## ANN ARBOR HISTORIC DISTRICT COMMISSION

### Staff Report

**ADDRESS:** 209 South Main Street, Application Number HDC12-164

**APPLICATION:** The applicant seeks HDC approval to replace six wood windows in the front elevation with six new wood windows.

3RD FLOOR WINDOWS  
TO BE REPLACED

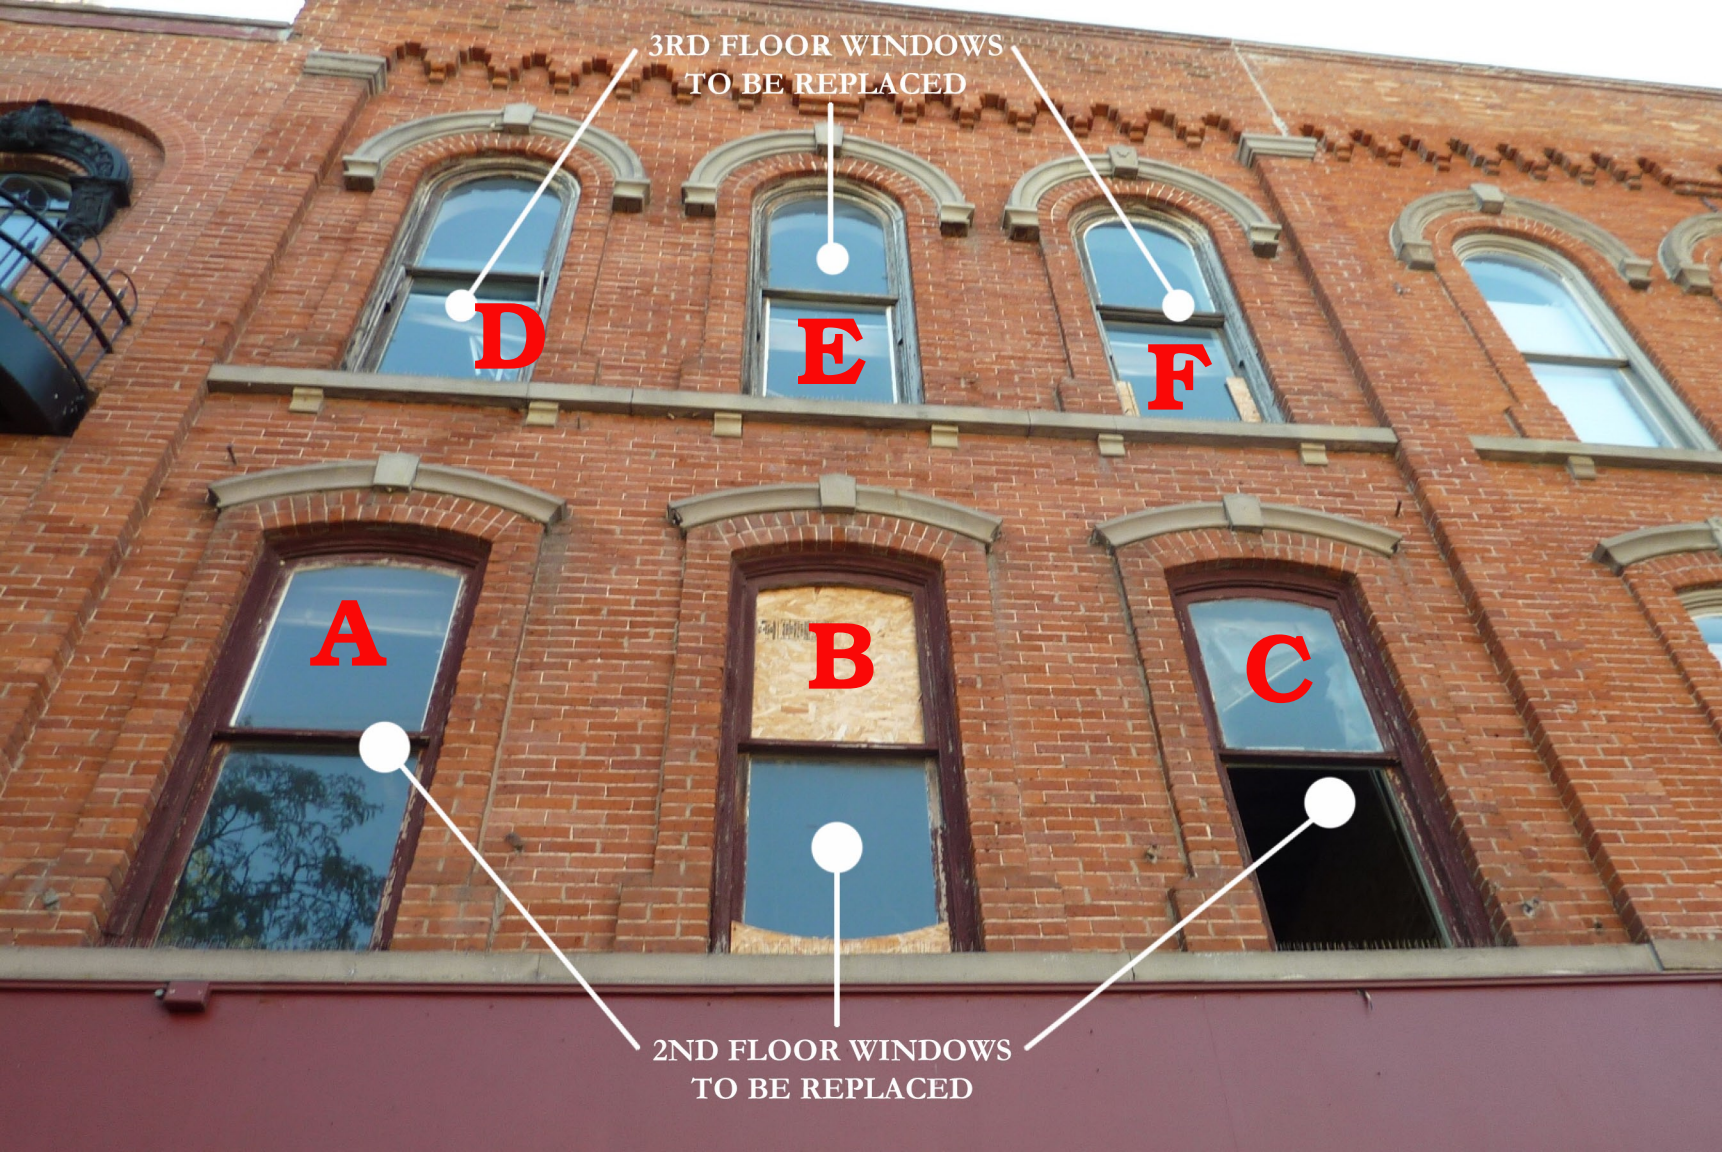
- A) Upper sash has severely weather damaged wood, North jamb stop missing, Lower sash has severely weather damaged wood, Sill needs replaced.
- B) Lower sash and jamb has severely weather damaged wood. Sill needs replaced.
- C) Upper sash has severely weather damaged wood as well as separation. Sill needs replaced.
- D) Both sashes have severely weather damaged wood with pieces missing, Glass missing, Sill needs replaced as well as brick molding.
- E) Both sashes have severely weather damaged wood with separation, glass missing, Sill needs replaced.
- F) Both sashes have severely weather damaged wood with missing pieces, glass missing, Sill needs replaced as well as brick molding.

**SASH- WINDOW 'C'-  
glass fell out onto  
sidewalk**

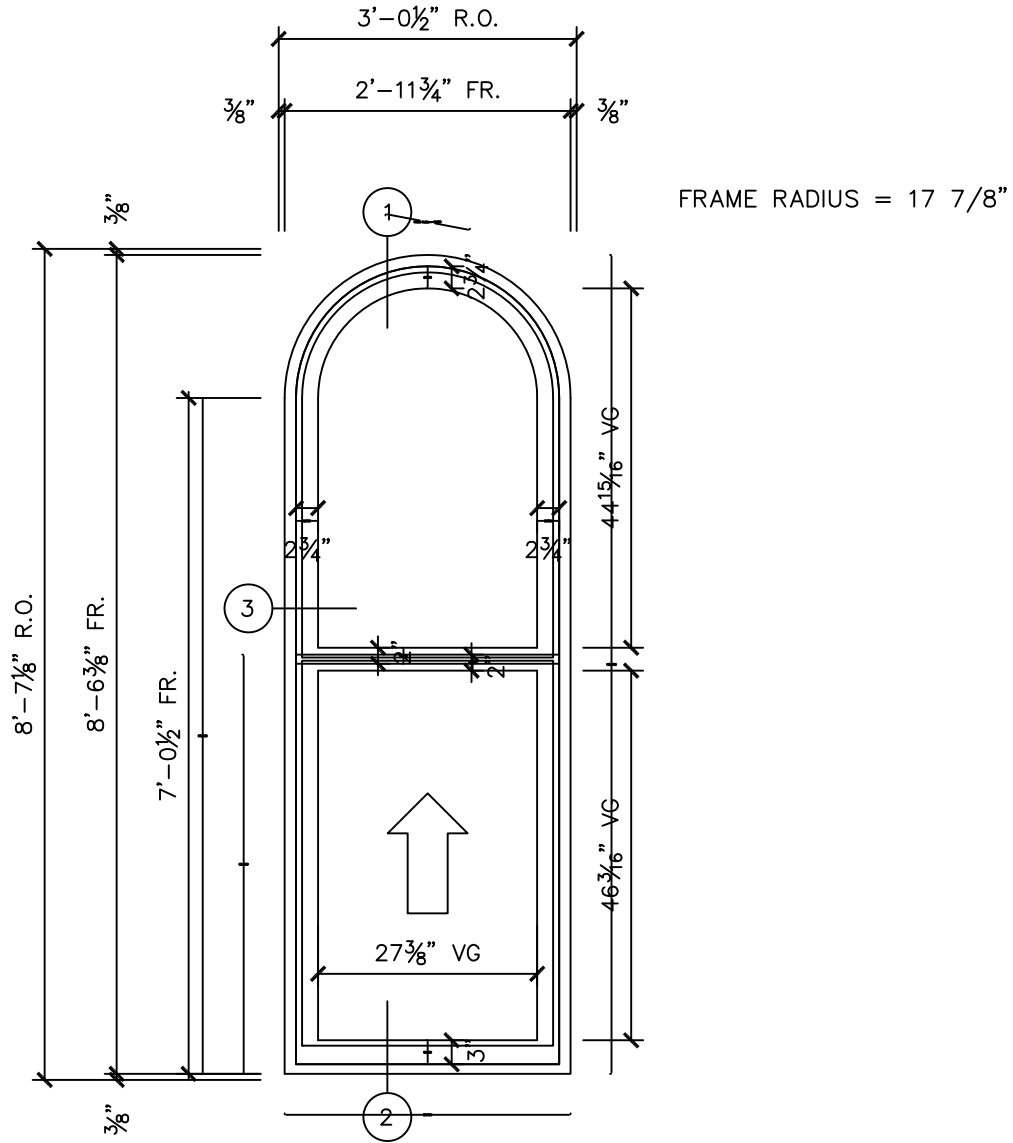
**wood plug  
completely rotted out**

**RAIL ROT & JAMB ROT:  
WINDOW F**

**TEMPORARY STOPS  
TO HOLD  
UNSECURED GLASS:  
WINDOW D**

**TYPICAL SILL:  
WINDOWS A,B,C  
sill significantly  
rotted away**

**note: unsecured  
glass, sill  
completely  
deteriorated**
